PCN for SMD kHz crystal, FC-255 taping and shipping spec

1. Affected Products : SMD type kHz Crystal unit
 - FC-255:Product code Q14FC255000**/Q13FC255000**

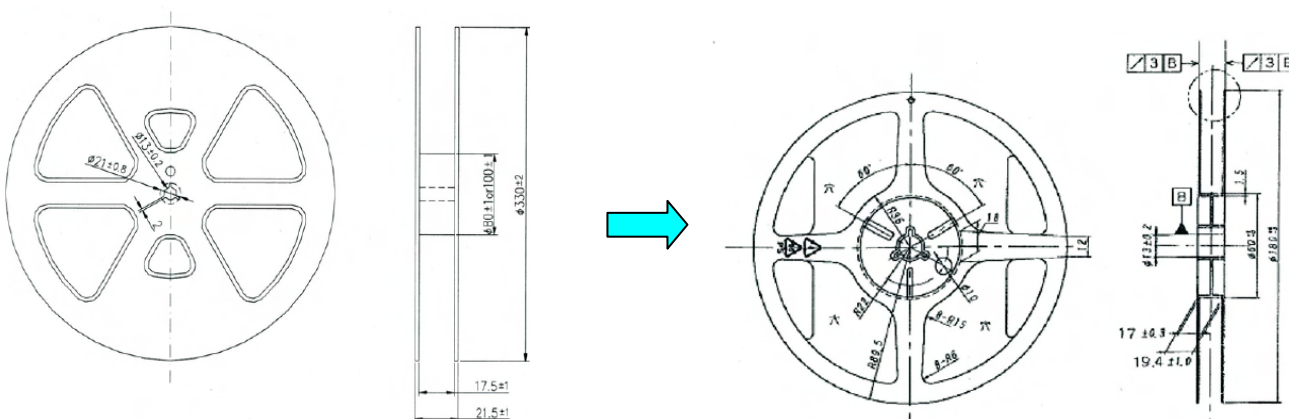
- (1) Crystal unit loading pitch of taping will be changed from 8mm to 4mm.

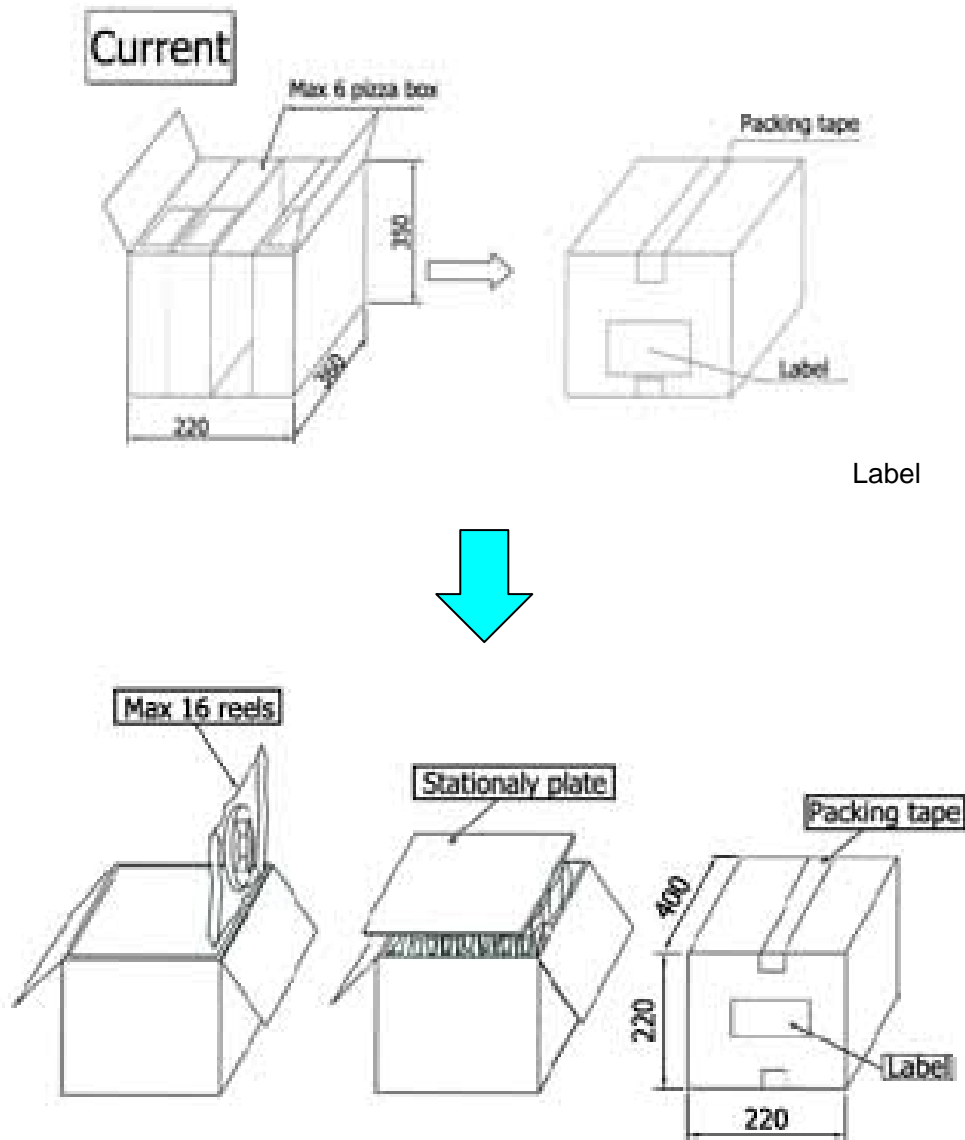
- (2) Reel diameter changed from φ330mm to φ180mm.

Reel diameter φ330mm

Reel diameter φ180mm
